Design Review Committee Meeting

3468 North Fulton Avenue
Hapeville, GA 30354

January 15, 2020 6:00 PM

DEPARTMENT OF PLANNING AND ZONING PLANNER'S REPORT

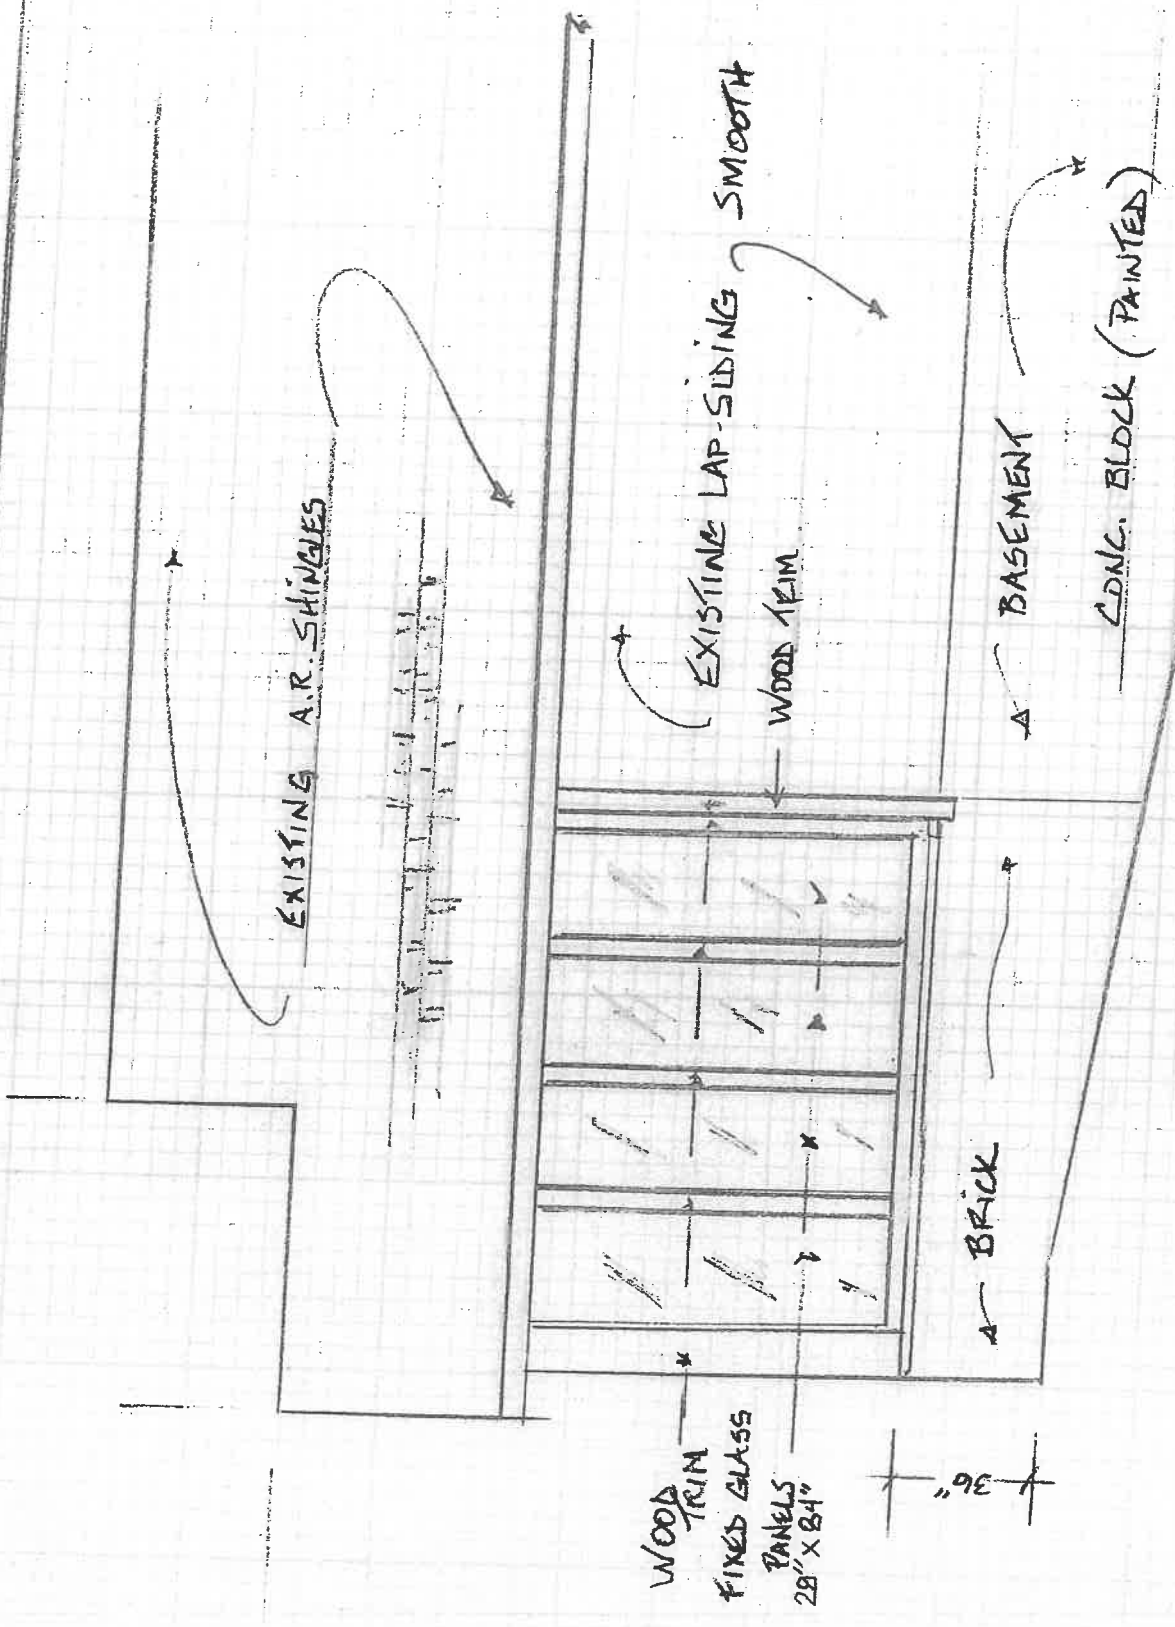
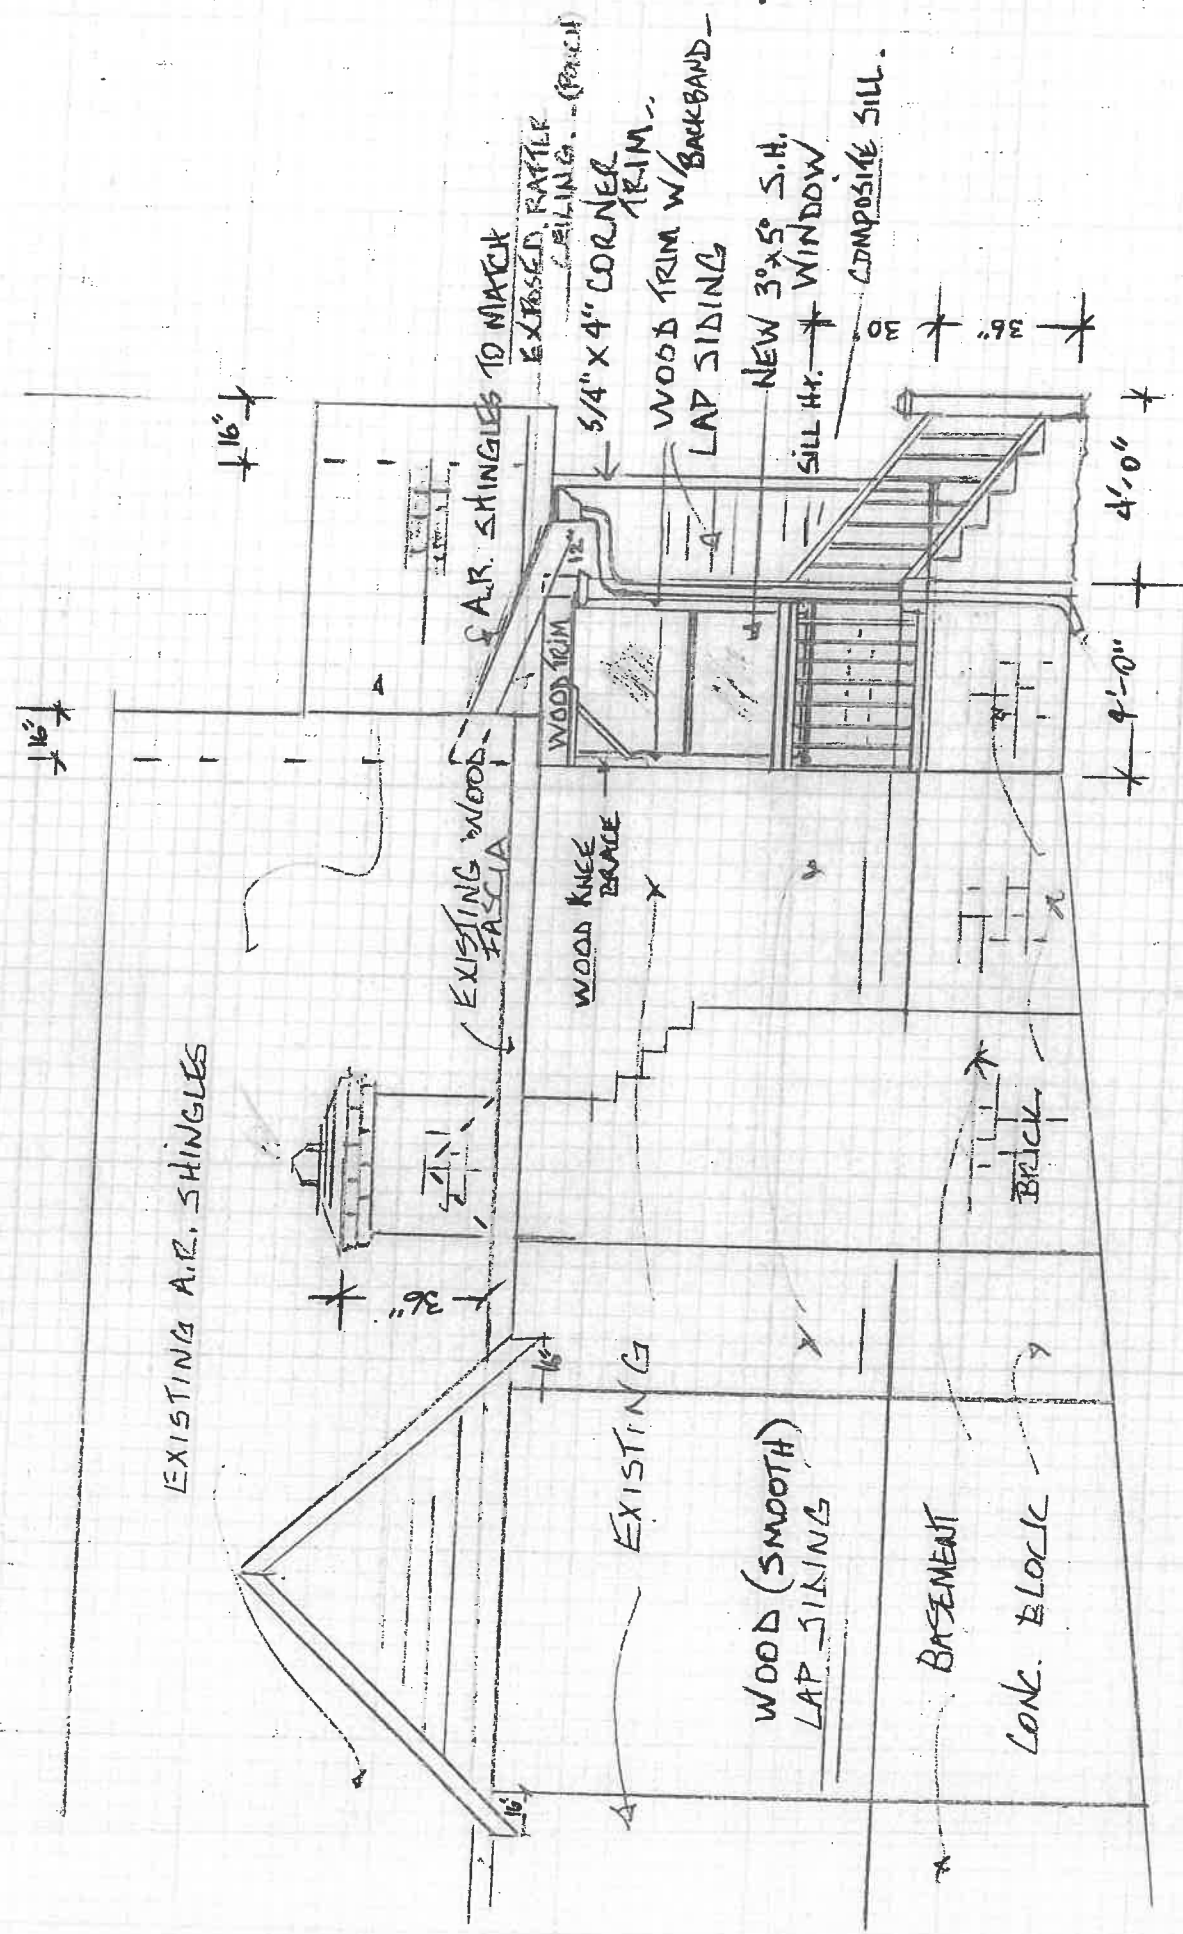
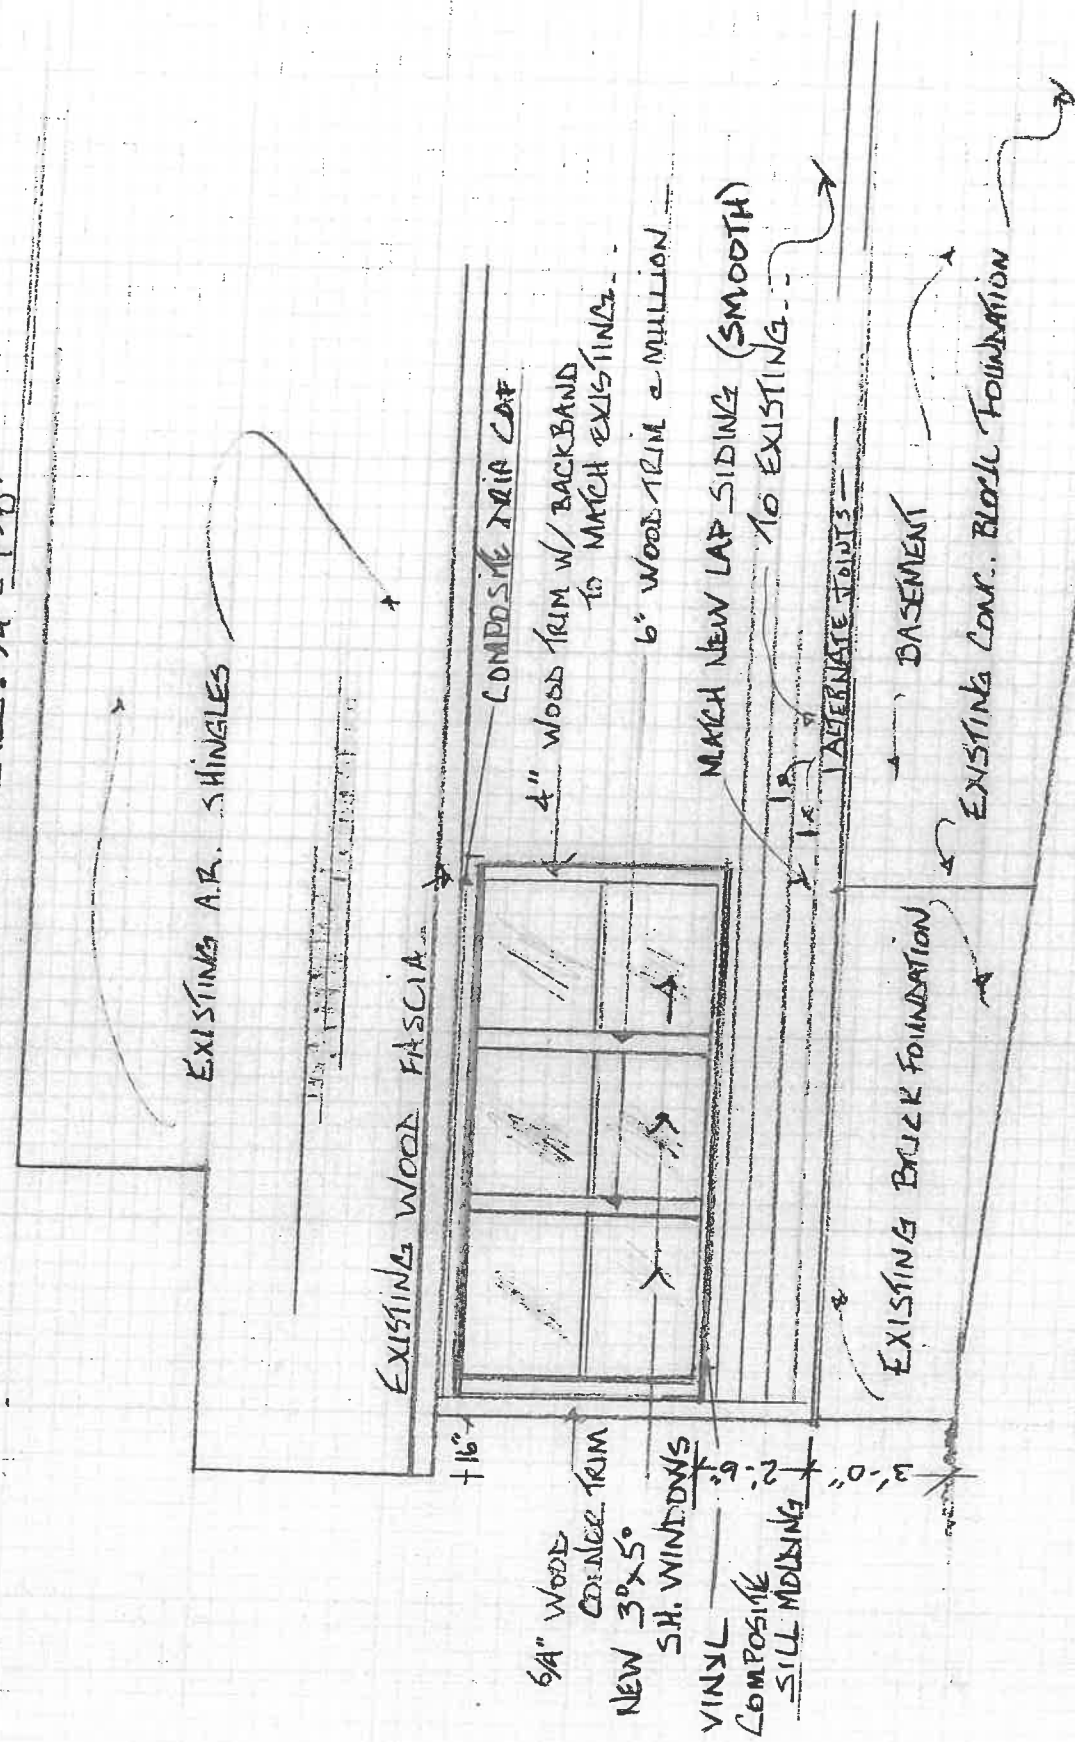
1. The porch width and depth are non-conforming, and the new porch columns will not extend to grade. However, the porch will use an existing concrete foundation and a design exception is recommended.
2. The applicant should ensure building numbers and a light at the front door are provided on the porch or adjacent to the front door.
3. With the sunroom, windows will be provided for greater than 50% of the enfronting façade, which is not compliant. However, while the proposed windows and façade are new, the overall window frontage would not change, and a design exception is recommended.
4. Windowsills must be made of masonry, wood, stone, cast stone, or terra cotta. The proposed windowsills are vinyl composite, which is not compliant.
